[Docket No. FAA–2013–0725; Directorate Identifier 98–CE–01–AD; Amendment 39–17690; AD 98–15–18 R1]

**Airworthiness Directives; Maule Aerospace Technology, Inc. Airplanes**

**ACTION:** Final rule.

Figure 1

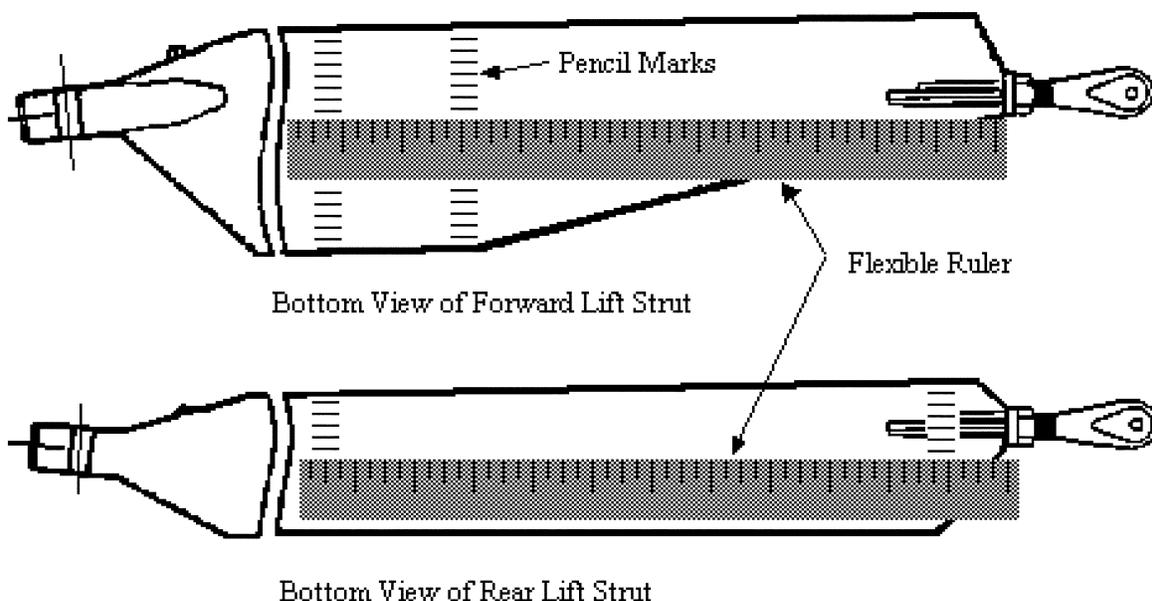
2. Using a flexible ruler, draw a 1/4-inch grid on the surface of the first 11 inches from the lower end of the strut as shown in Maule Air, Inc. Service Bulletin No. 11, dated October 30, 1995, as applicable. This can be done using a soft (#2) pencil and should be done on both faces of the strut. As an alternative to drawing a complete grid, make two rows of marks spaced every 1/4 inch across the width of the strut. One row of marks should be about 11 inches from the lower end of the strut, and the second row

should be several inches away where the strut starts to narrow. Lay the flexible ruler between respective tick marks of the two rows and use tape or a rubber band to keep the ruler in place. See Figure 1.
